UNITED STATES PATENT AND TRADEMARK OFFICE

APPLICATION NO.	FILING DATE	FIRST NAMED INVENTOR	ATTORNEY DOCKET NO.	CONFIRMATION NO.
10/588,489	08/04/2006	Eric Perouse	2006_1244A	6680

Office Action Summary	Application No. 10/588,489	Applicant(s) PEROUSE, ERIC	
	Examiner JOCELIN C. TANNER	Art Unit 3731

DETAILED ACTION

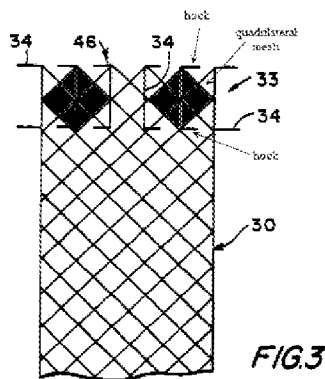
5. Regarding claim **27**, Berg et al. ('048) discloses meshes of a lattice having a shape of a deformable quadrilateral wherein the at least two hooks are connected to the lattice at a respective corner of the meshes. Please see figure above.

19. Regarding claim **39**, Berg et al. ('048) discloses meshes of a lattice having a shape of a deformable quadrilateral wherein the at least two hooks are connected to the lattice at a respective corner of the meshes. Please see figure above.
